## **Proposal for the 04 series of amendments to UN Regulation No. 129**

### **Submitted by the expert from the European Association of Automotive Suppliers**

The text reproduced below was prepared by the expert from the European Association of Automotive Suppliers (CLEPA) to include corrections related to CLEPA formal document ECE/TRANS/WP.29/GRSP/2018/29 that defines the introduction of booster cushions into Regulation R129. The modifications to the formal document are marked in bold for new or strikethrough for deleted characters.

**Figure 2**  
**Ruler of measurement device:**

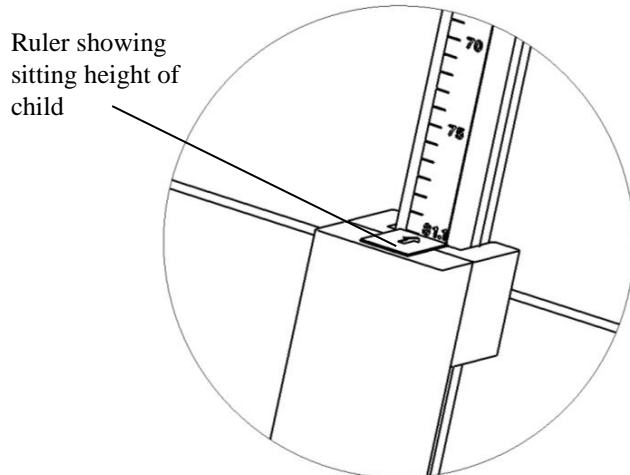
*Delete Figure 2*

*Insert new Figure 2*

- (a) The measured distance between the two points M and N represents the sitting height of a child who will use the cushion represented in Figure 1. The corresponding value is displayed by a ruler that is provided with the device as shown in Figure 12.
- (b) ...

## "Annex 2

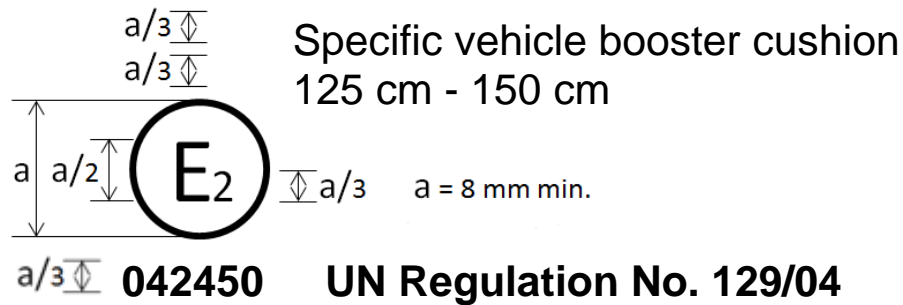
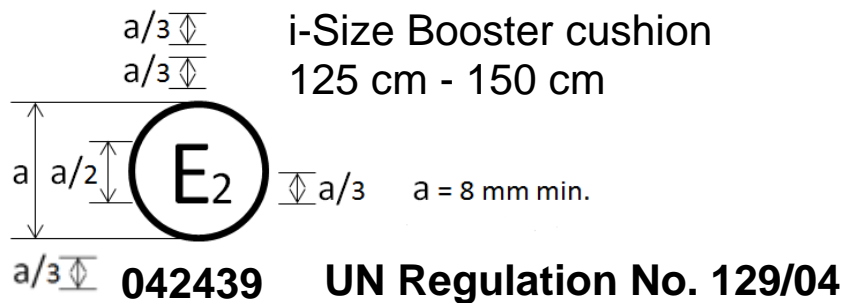
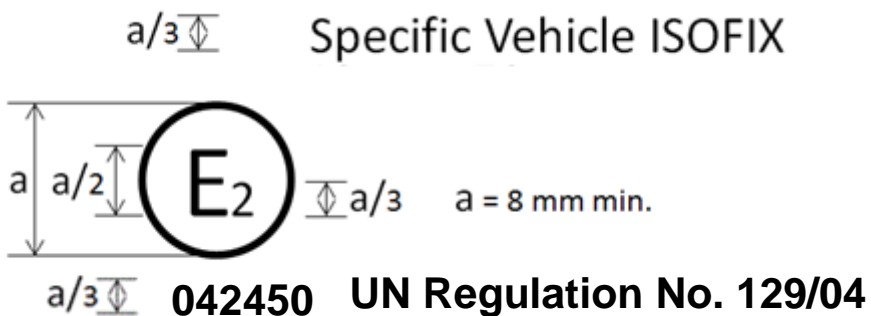
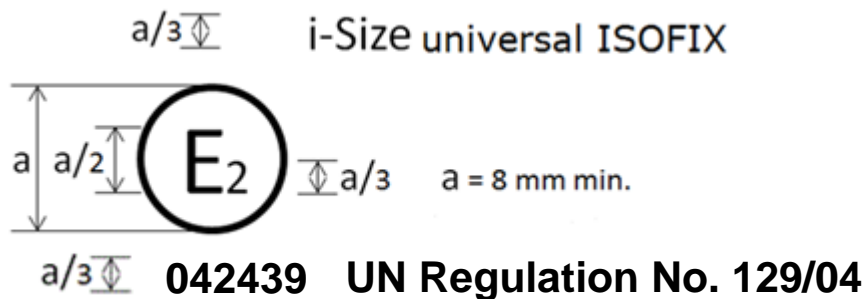
Annex 2, amend to read:

### 1. Arrangements of the approval mark

... according to which the approval has been granted.

2. Arrangements of the approval mark in combination with a module mark

### Measurement device for booster cushion height check

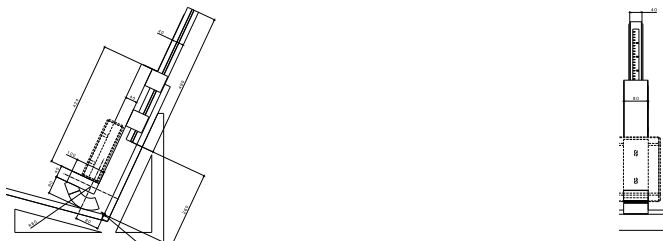
Delete Figure

Insert new Figure:

**The mass of the device shall be 15kg +/-1kg**

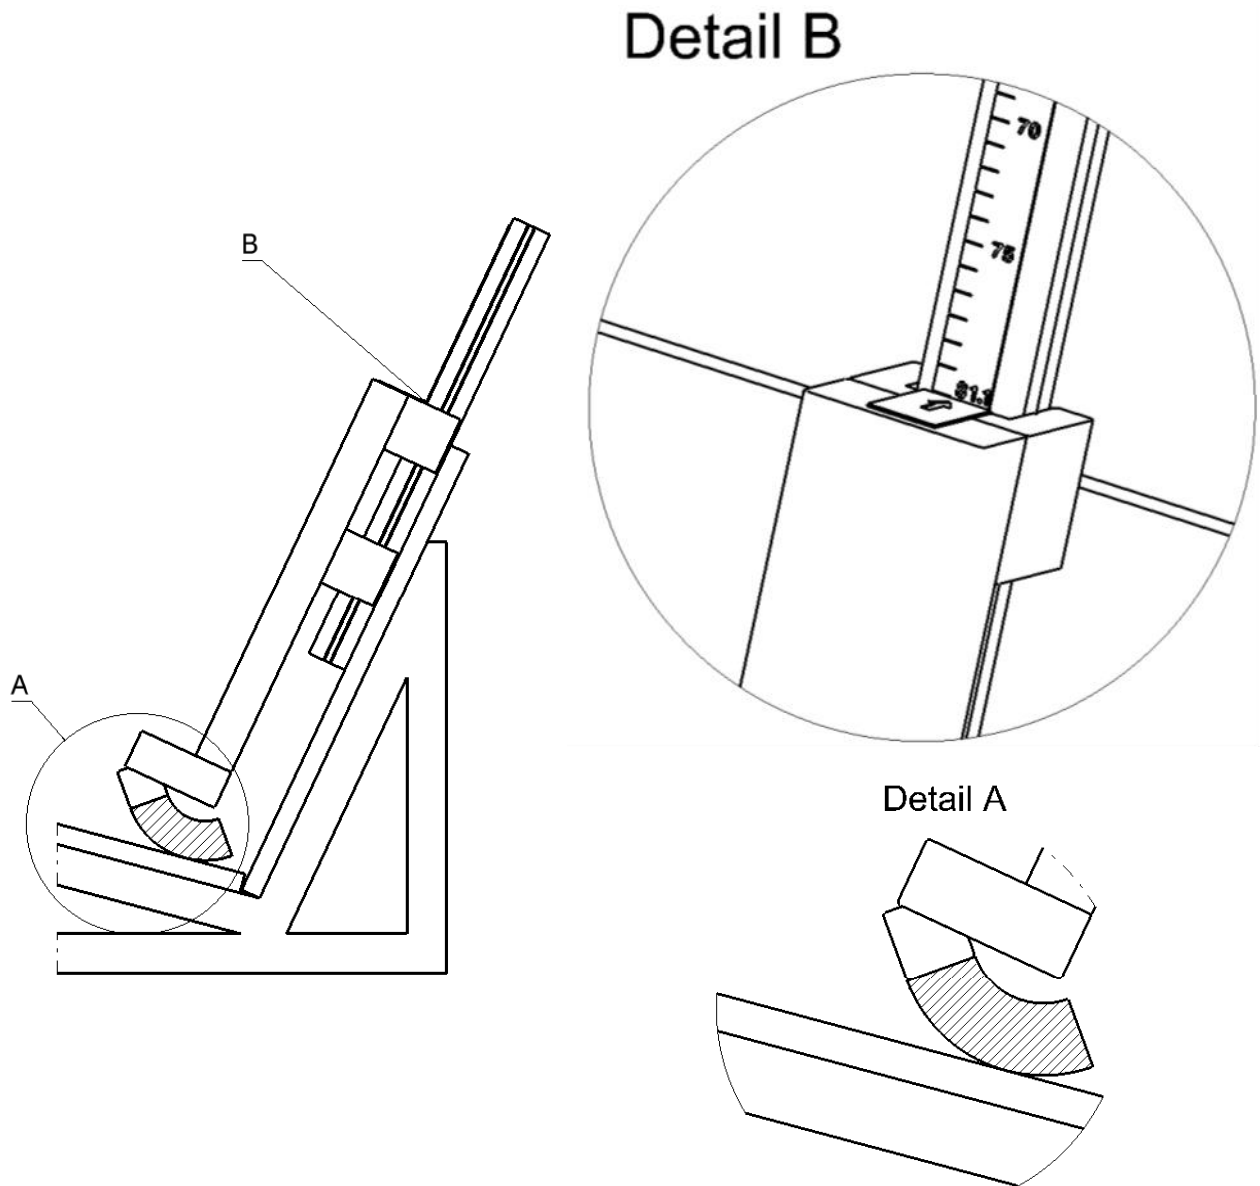
Delete Figure

Insert new Figure:
